Docket Item #4
BAR CASE #2006-0231

BAR Meeting
November 29, 2006

ISSUE: Addition and alterations

LOCATION: 310 North Fayette Street

Figure 1 - East elevation

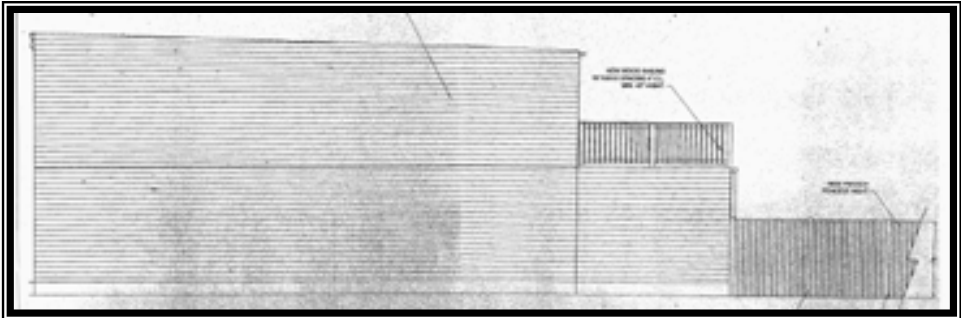
The applicant has removed several sections of the existing aluminum siding—a section on the front and a section on the rear. The unpainted wood beneath the aluminum does not match any historic siding configuration associated with buildings of this era. It appears to be wood used as a sub-layer on which the aluminum siding was affixed. Staff visited the site and looked at the wood and the applicant has provided photographs. The applicant has proposed removing all the aluminum and replacing with new Hardi-plank.

While no historic siding appears to remain underneath the existing aluminum siding, staff is concerned about the use of Hardi-plank on all elevations of this building. In previous cases, the

Board has allowed the use of Hardi-plank as a replacement material on secondary elevations. The use of Hardi-plank on the new addition is not problematic. In keeping with the Board's policy, staff would recommend that wood be used on the front elevation and that the Board consider the approval of using Hardi-plank on the sides and the new addition.

1. That wood siding is used to replace the aluminum siding on the front elevation;
2. That Hardi-plank may be used on the side elevations and the new addition, with the Hardi-plank to be a smooth finish and that the nails not show in the installation;
